Date : 15/01/2020 2:07:43 PM
From : "WEISE Tom"
To : [sch4p4(6) Personal information]@cleanaway.com.au"
Cc : "GREENWOOD Angela"
Subject : APP0046216 - Cleanaway New Chum Cell 3B1 - Query
Attachment : image001.png;image002.png;image003.png;
Hi [Sch4p4(6) Personal i]

Subject : Cleanaway - New Chum update

Subject (Detail): Teams meeting summary File Note

Subject (Detail): Notes from Surface Water Discussion – New Chum Landfill

Figure 1: Existing landfill footprint with proposed lateral and vertical extension and associated infrastructure.

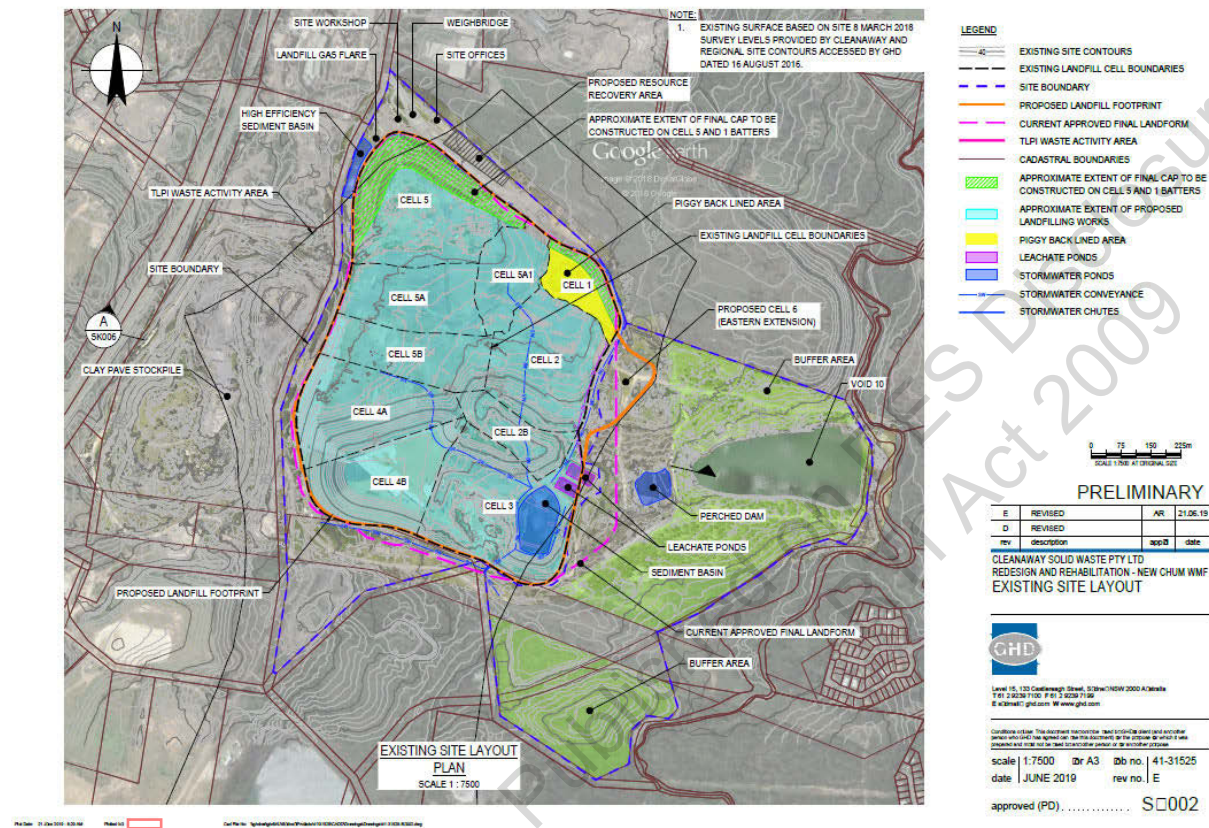
Commented [GA2]: This figure is noted as Figure A2.1 from the GHD concept design report and will be copied into the appendix of the EA.

Both discharge points are shown in current EA table – and provided in the attached figure for completeness. Neither of these discharge points are changing under the current application.

Commented [GA4]: Cleanaway to provide co-ordinates for LPD 1.
